SUBDIVISION REPORT - FINAL PLAT

►	FILE	#:	4-SA-22-F
· ·	FILE	#.	4-3A-22-F

► SUBDIVISION: FINAL PLAT OF THE RESUBDIVISION OF LOTS 1, 3, & 4 OF THE JAMES CHRISTIAN PROPERTY APPLICANT/DEVELOPER: **NED FERGUSON** Scott Wolf and Cameron Price OWNER(S): TAX IDENTIFICATION: 80 E C 049, 04901, & 04903 View map on KGIS JURISDICTION: City Council District 5 STREET ADDRESS: 1635 1637, 1641, and 1647 Wilson Rd. ► LOCATION: Northwest side of Wilson Rd, east of Wilson Heights subdivision SECTOR PLAN: Northwest City

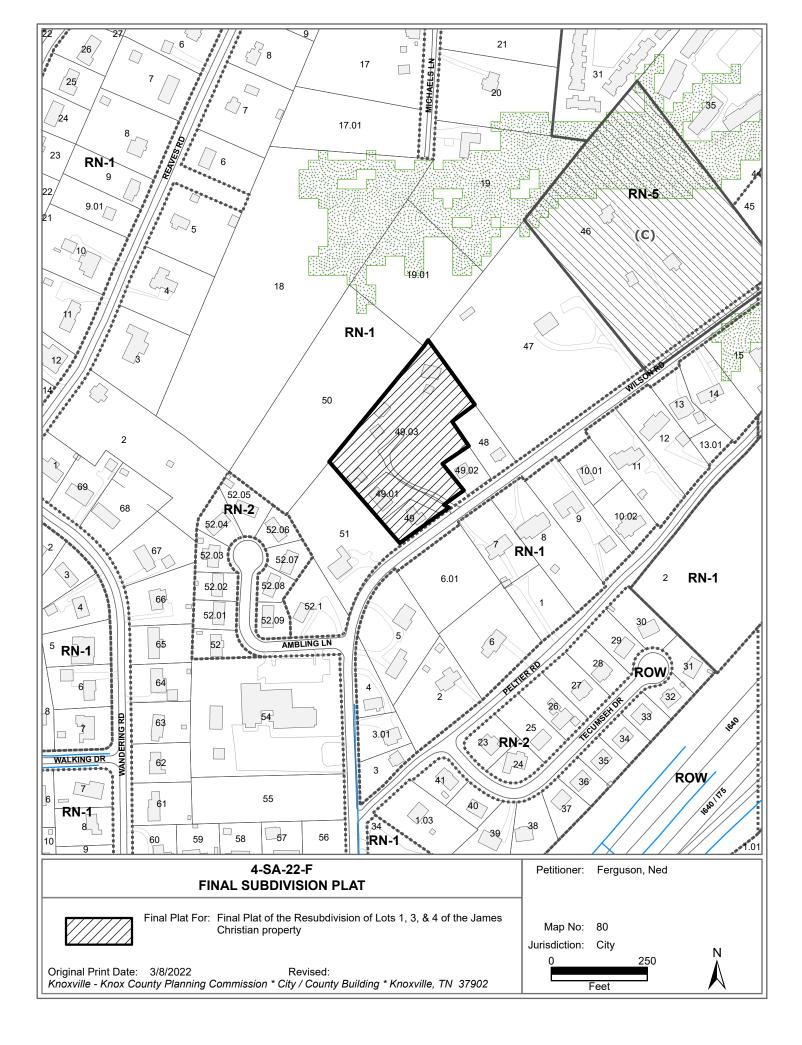
1) This plat is a resubdivision of four properties along Wilson Road. There are a few complications with the plat that cause a need for the requested variance.

2) Wilson Road is classified as a major collector and requires a 60-ft right-of-way according to the 2018 Major Road Plan. The right-of-way width in front of lot 1 is approximately 52 ft wide, so there needs to be an additional 8 ft of right-of-way at this location.

3) In 1977, Lots 2 and 4 were platted, and Lot 1 was created in 1988. These plats created a void where lot 3 is located. Since Lot 3 was never platted, this plat technically creates an additional lot and right-of-way dedication is required.

4) The lot across the street was platted in 2004 showing 30 ft to the centerline of the right-of-way on that side of the road. This being the case, the additional 8 ft would have to be dedicated from this lot for the right-of-way width to be in compliance with the Major Road Plan.

5) The house on Lot 1 was built in 1935. The plat of Lot 1 in 1988 created a nonconformance at the time, as the house is located 18.5 ft from the right-of-way line, and the R-1 zoning at the time of the plat required a 25-ft

front setback. It does not appear that a variance or right-of-way dedication was required, and the plat recorded the lot as it is shown today, with a nonconforming front setback.

6) The Subdivision Regulations state that a plat cannot make a nonconforming situation worse. The house on Lot 1 is 18.5 ft from the right-of-way line, so the 8-ft dedication would put the house 10.5 ft from the right-of-way line. The applicant is seeking a variance from the right-of-way dedication requirement of the subdivisions.

Approve the variance request to reduce the right-of-way in front of Lot 1 because the existing house is too close to the right-of-way line.

Approve the final plat because it is in compliance with the Subdivision Regulations.
